# FY 2025-26 Standard Plans Update Training

Rick Jenkins, P.E  
State Standard Plans Engineer  
Roadway Design Office  
[Rick.Jenkins@dot.state.fl.us](mailto:Rick.Jenkins@dot.state.fl.us)

## STANDARD PLANS FY 2025-26 REVISIONS LOG

## Sheet 13: MUTCD Update

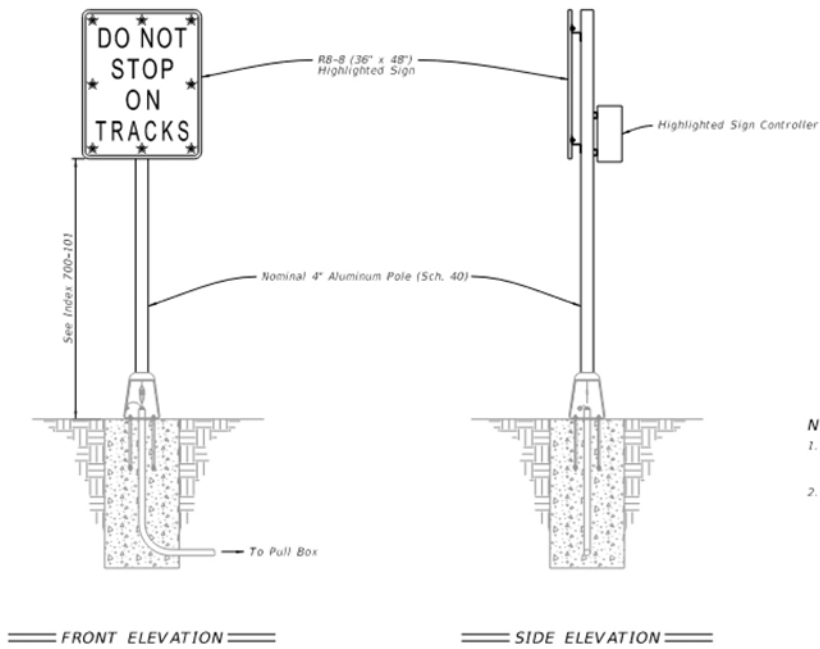
- Added LEDs in the middle of each sign edge, for a total of 8 LEDs.

## Sheet 14: MUTCD Update

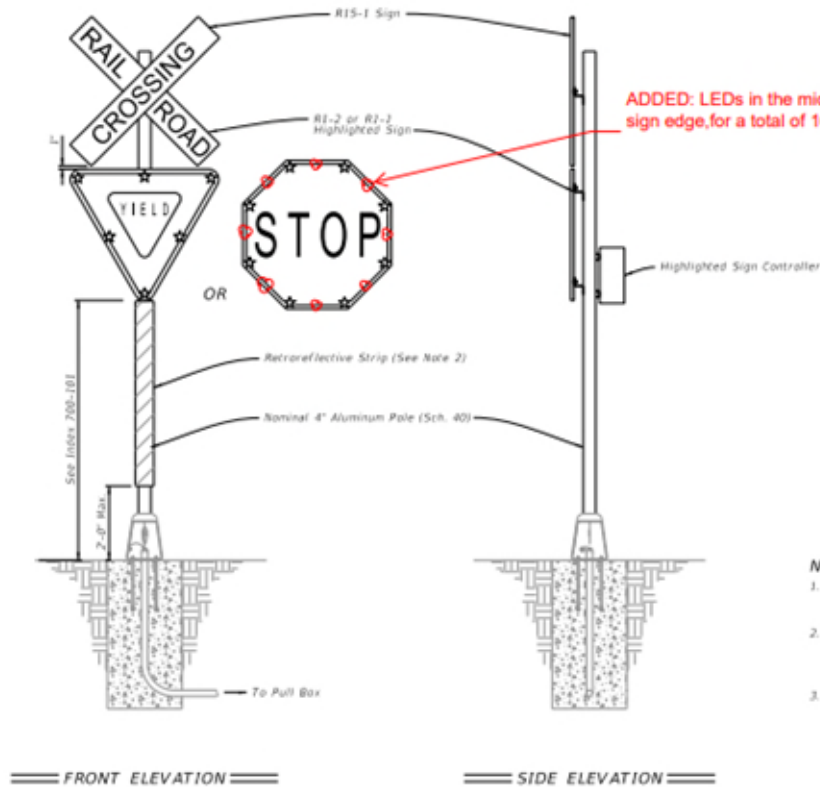
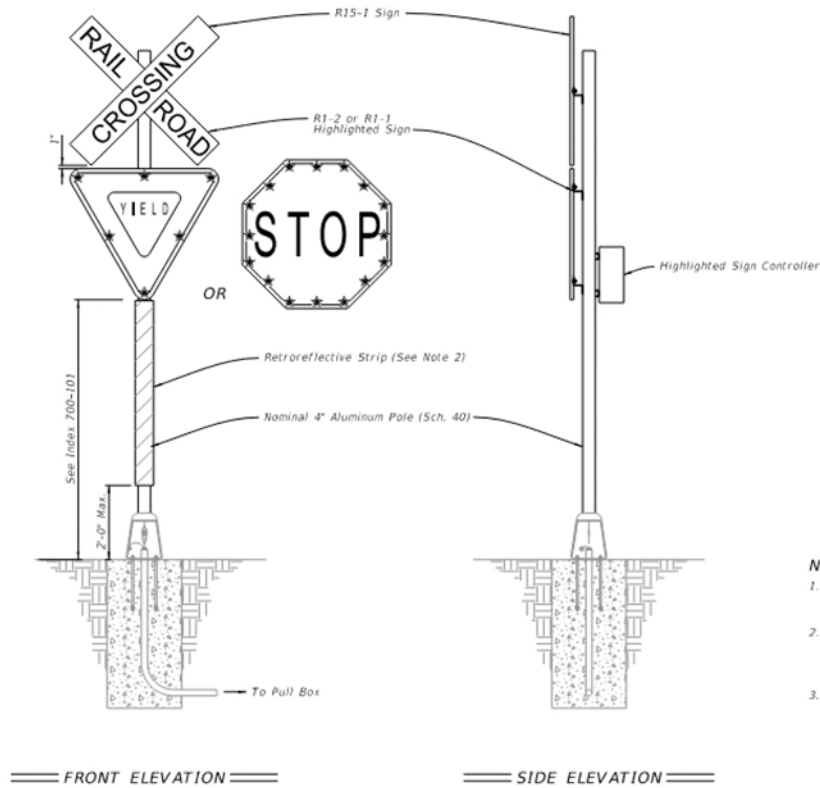
- Added LEDs in the middle of each sign edge, for a total of 16 LEDs.

## Sheet 7: Update to Flip Signs

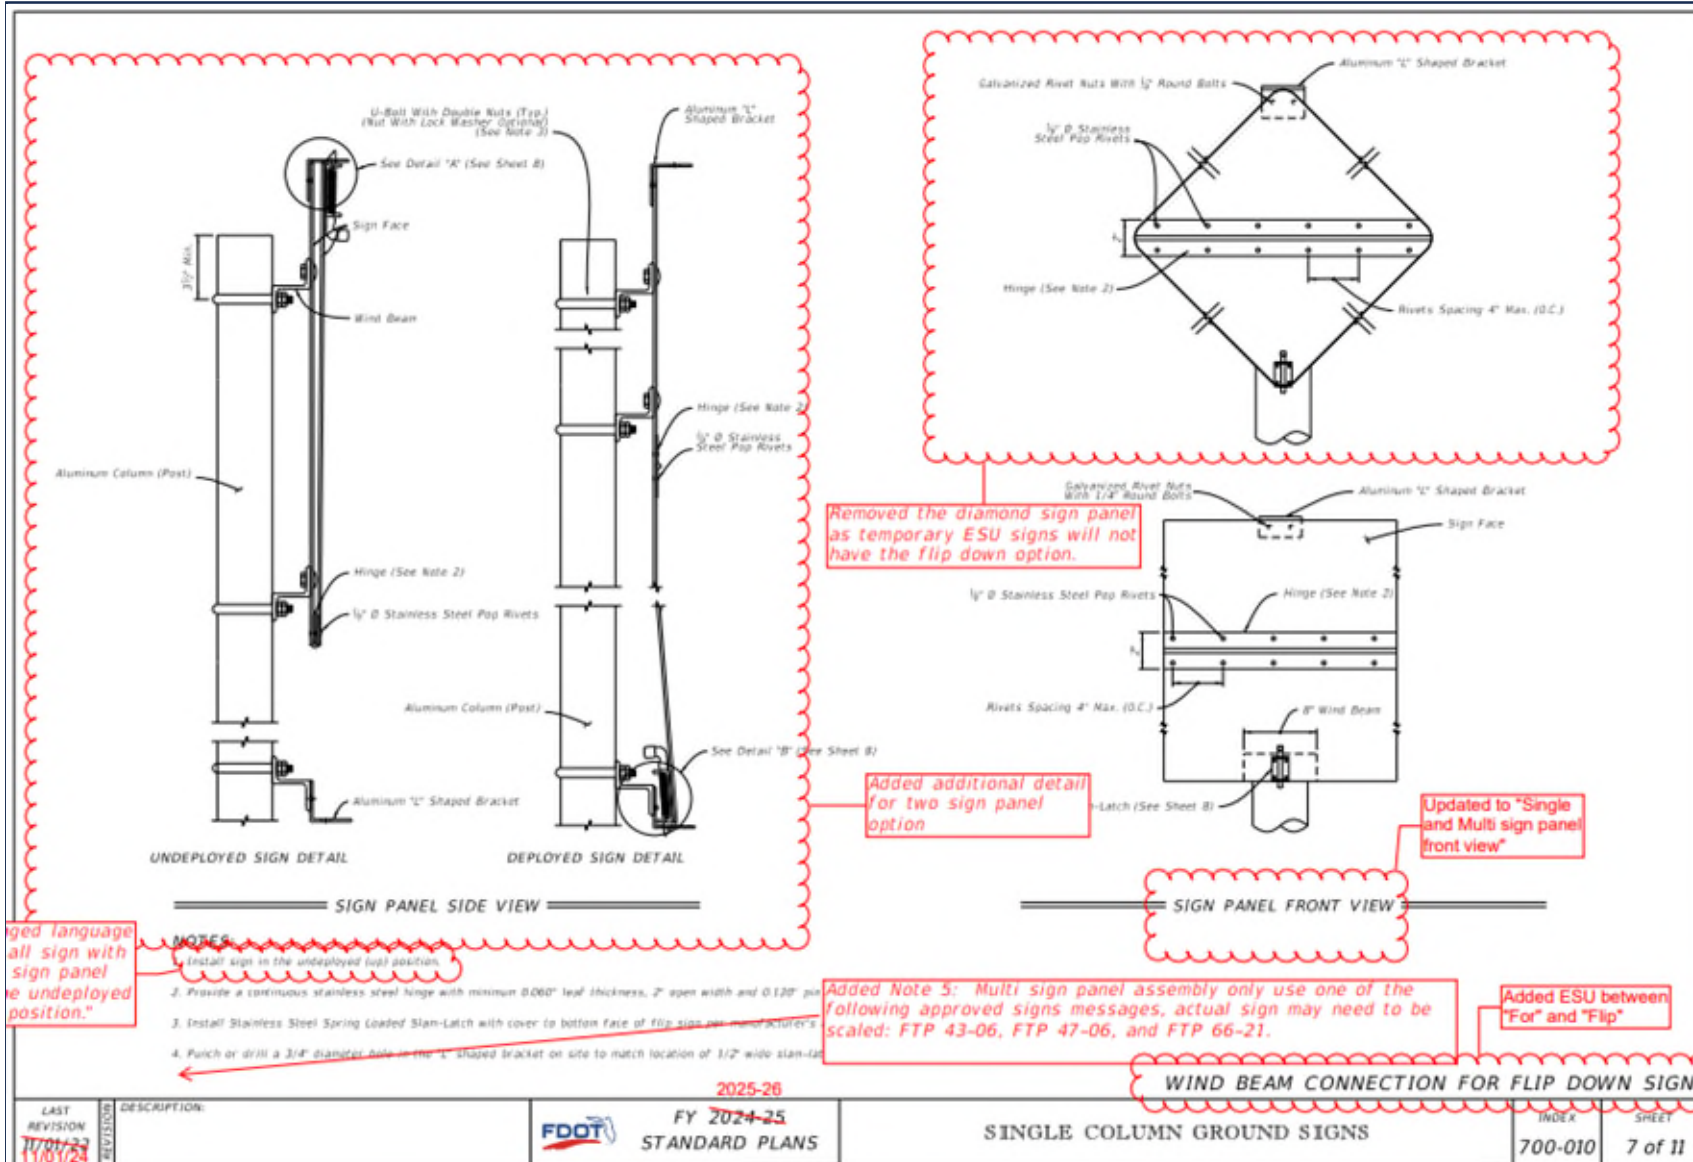
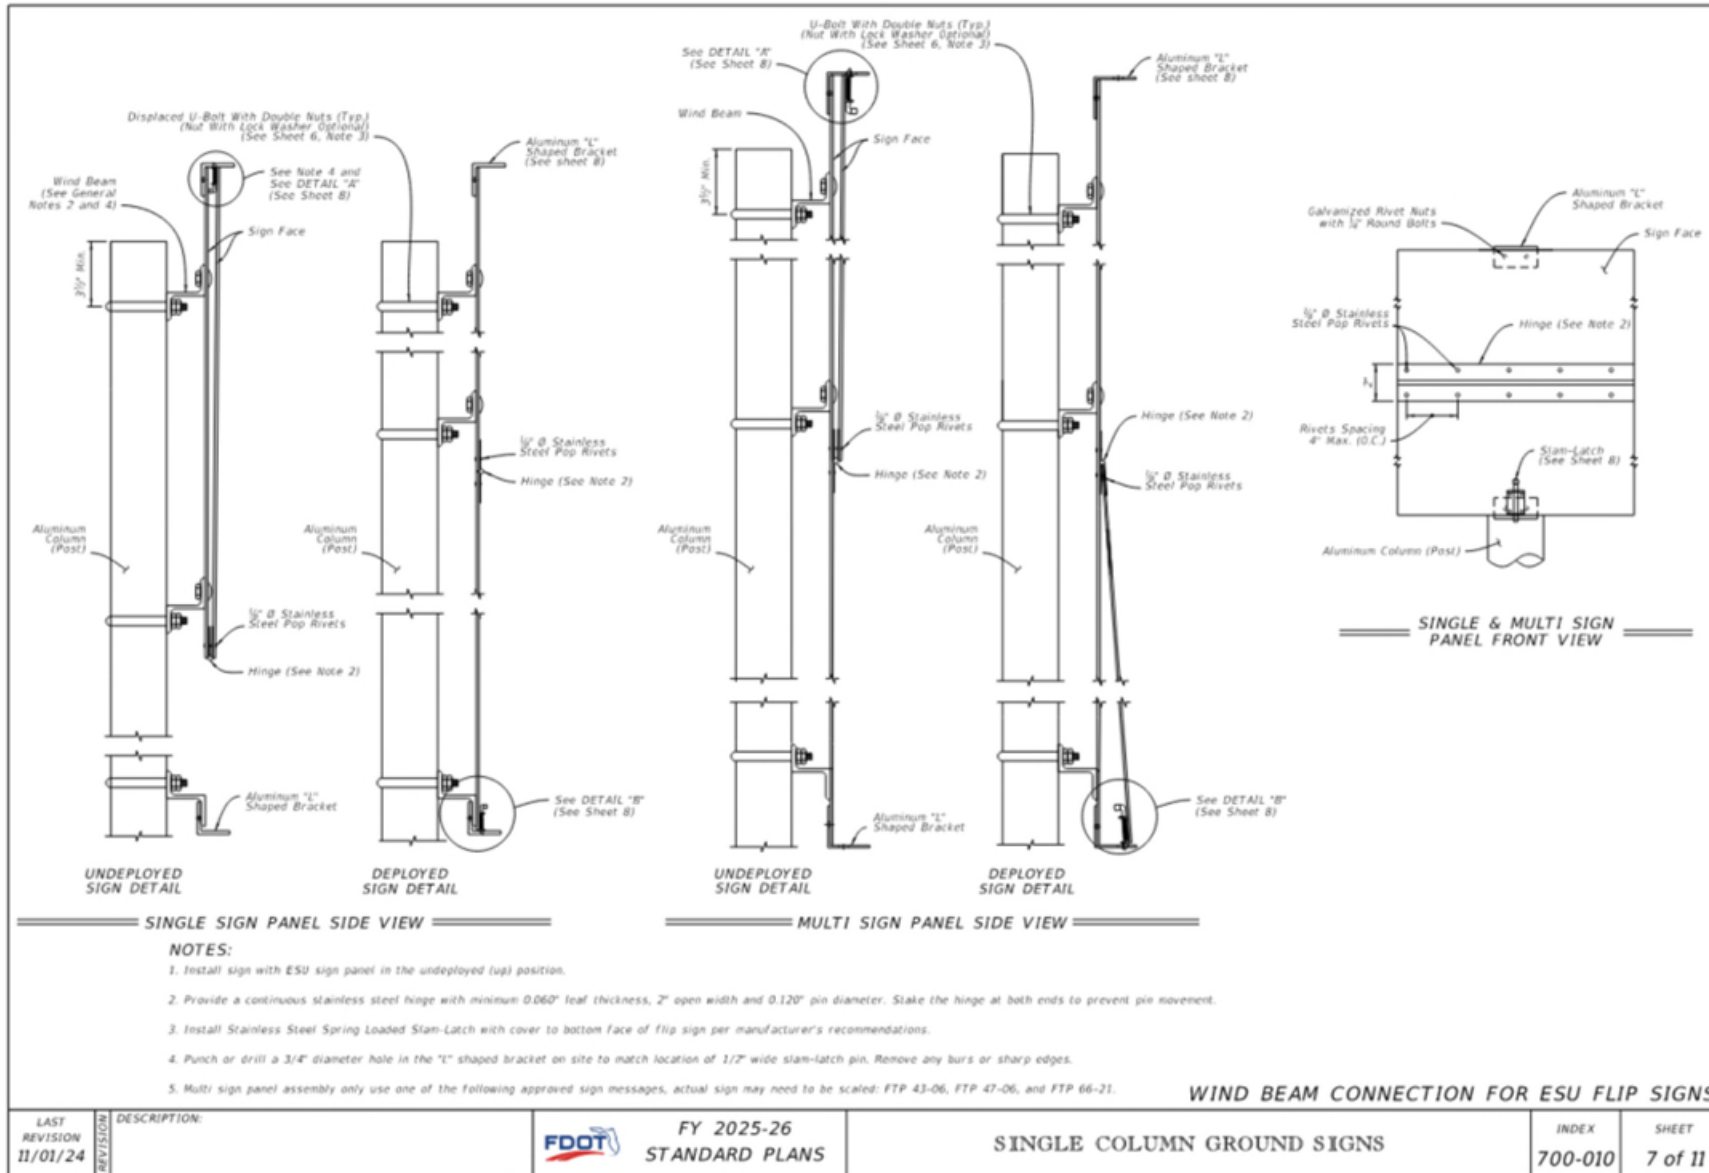
- Updated the flip sign to allow for multiple sign panels
- Removed the diamond sign panel
- Updated Note 1 to "Install sign with the ESU sign panel in the undeployed (up) position."
- Added Note 5 "Multi sign panel assembly only use one of the following approved signs, actual sign may need to be scaled: FTP 43-06, FTP 47-06, and FTP 66-21."
- Added ESU to sheet title.

## Sheet 4: Managed Lane

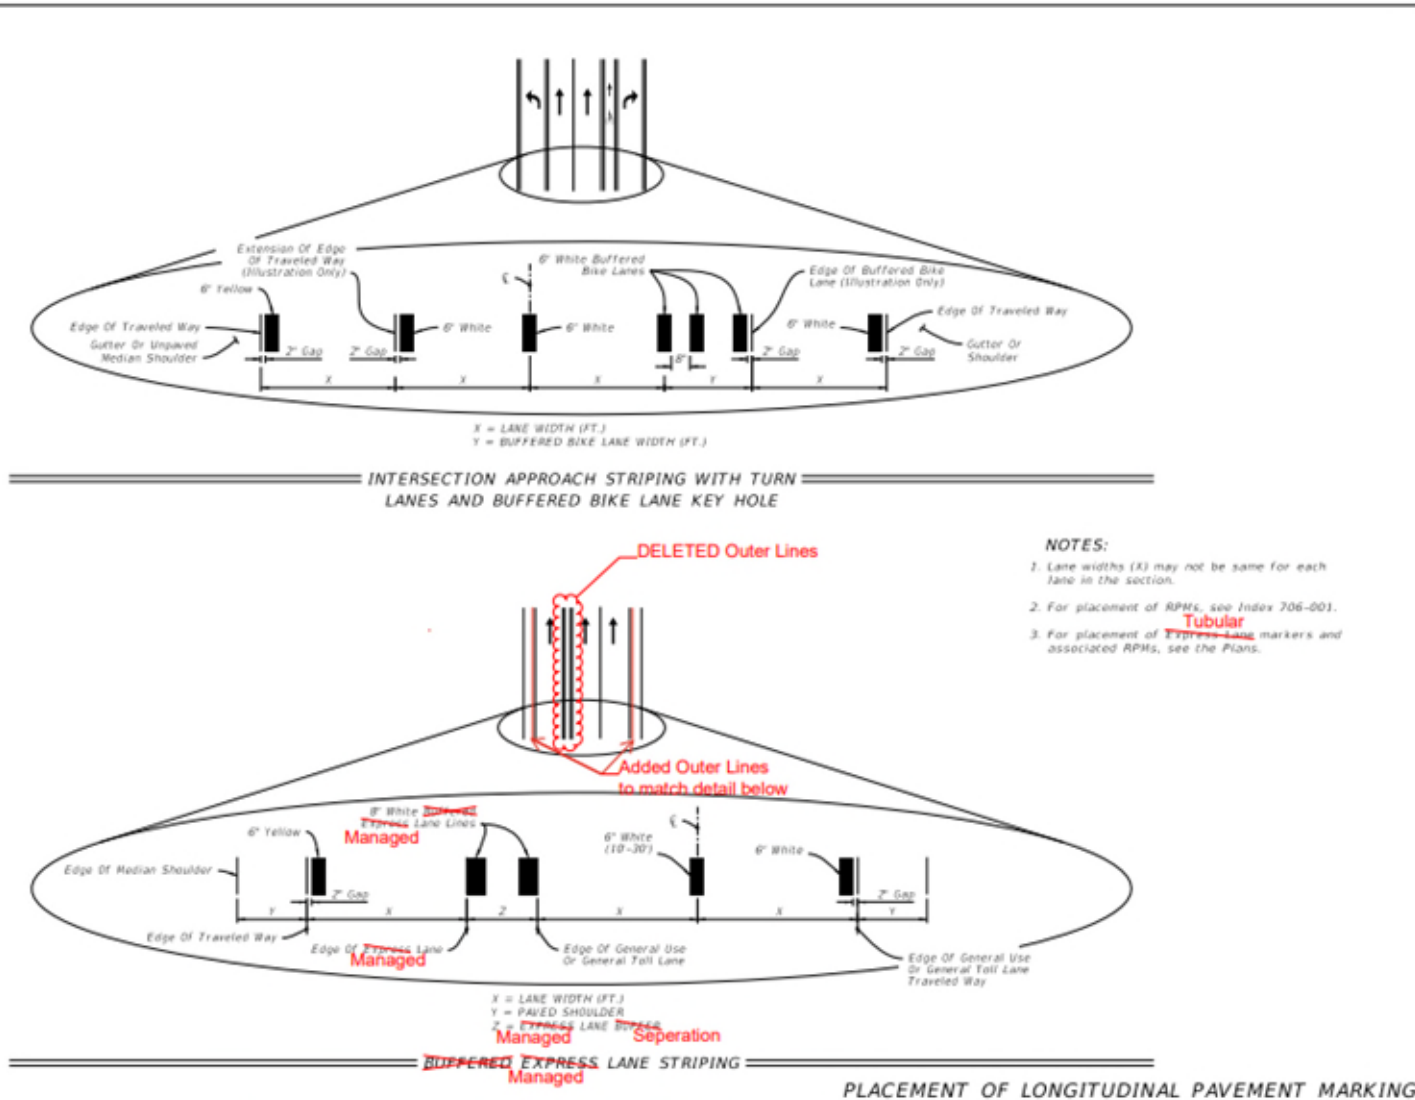
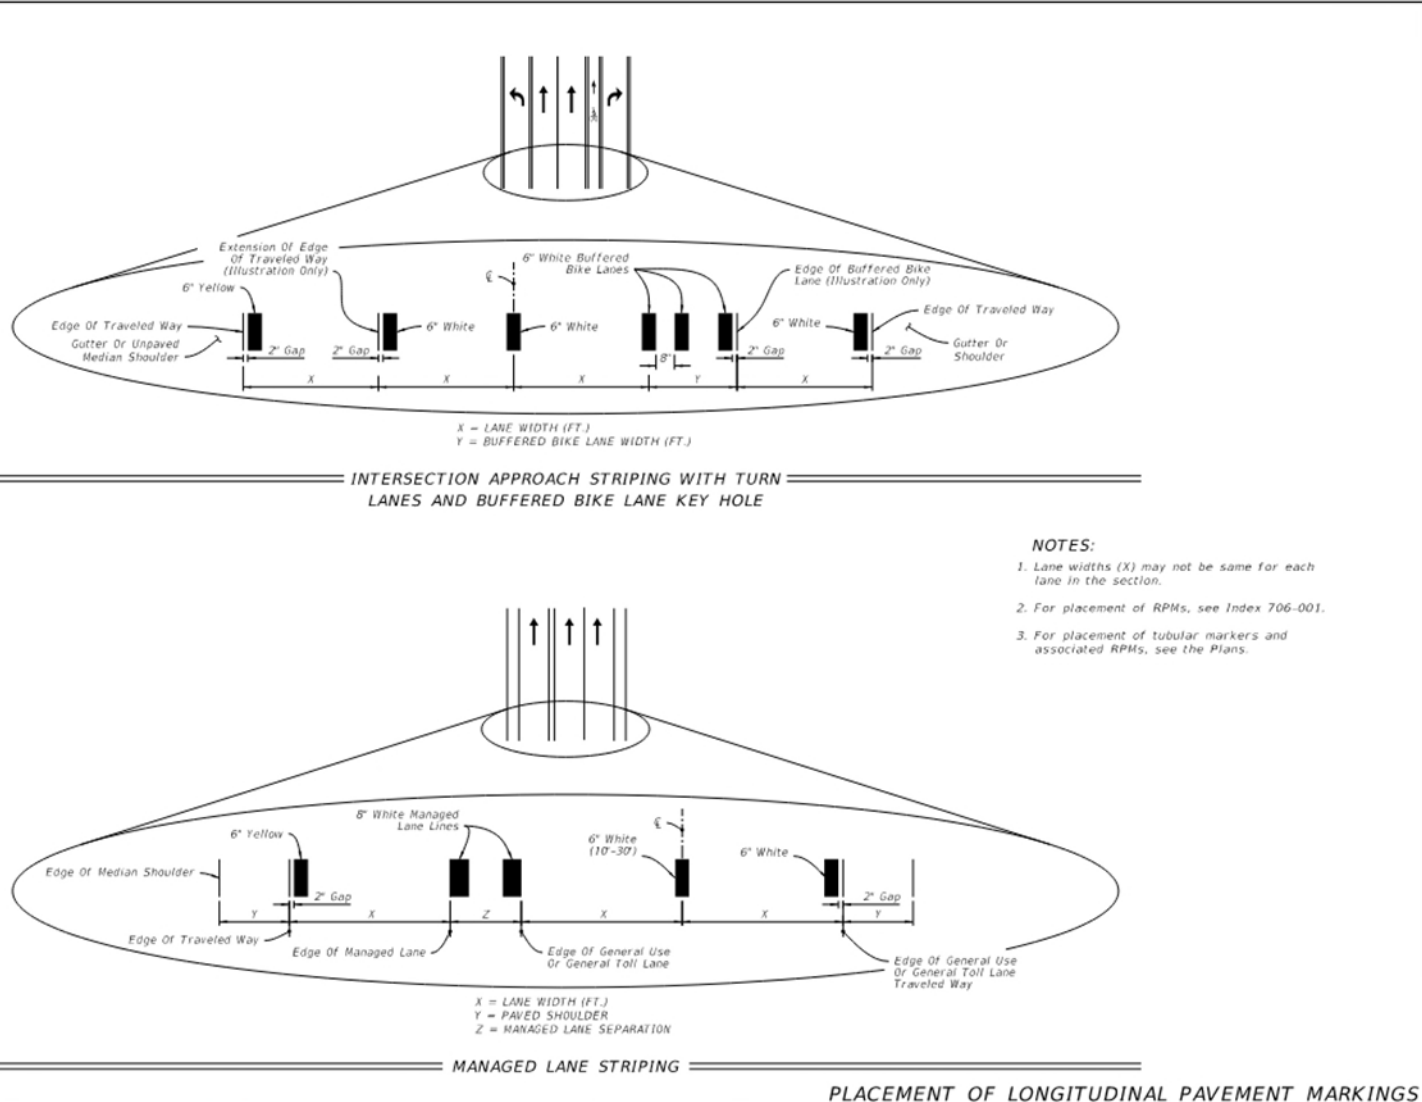
- Updated Buffered Express Lane Striping Detail to replace "Express" with "Managed" in title and callouts
- Deleted "Buffered" in detail title and callout
- Replaced "Buffer" with "Separation" in callout
- Deleted extraneous lines from the detail
- Updated Note 3 to replace "Express Lane" with "Tubular"

THRIE-BEAM GUARDRAIL POSITIONING DETAIL

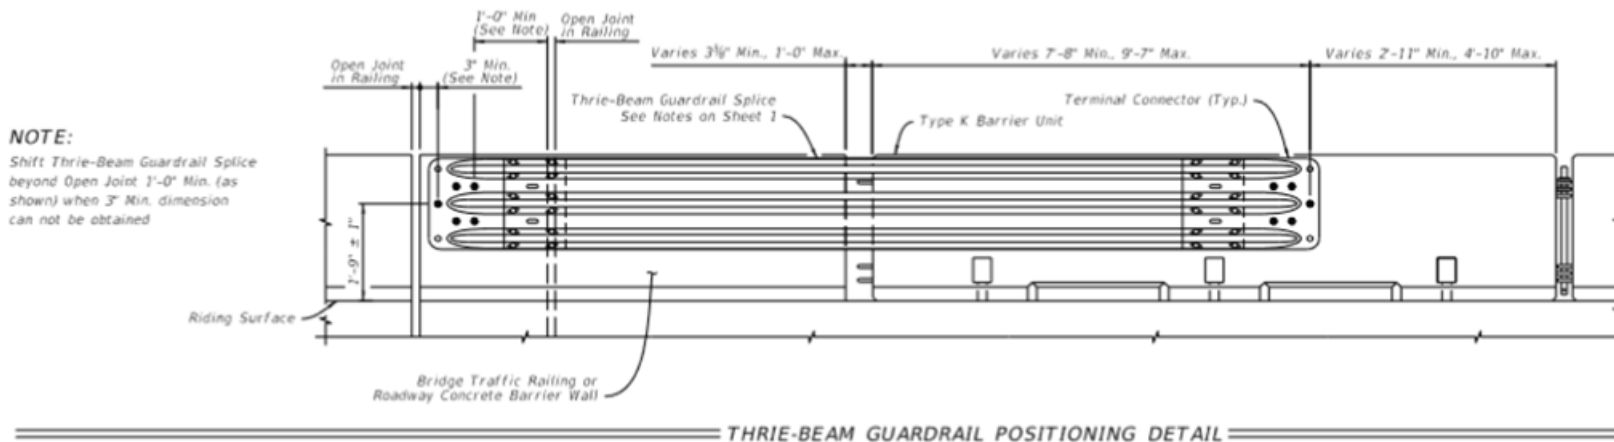
- Also, ensure that ...Installation Note 3 is followed for connecting to trailing ends of Single-Slope Barriers & Traffic Railings:

**NOTE:**  
Shift Thrie-Beam Guardrail Splice beyond Open Joint 1'-0" Min. (as shown) when 3" Min. dimension can not be obtained
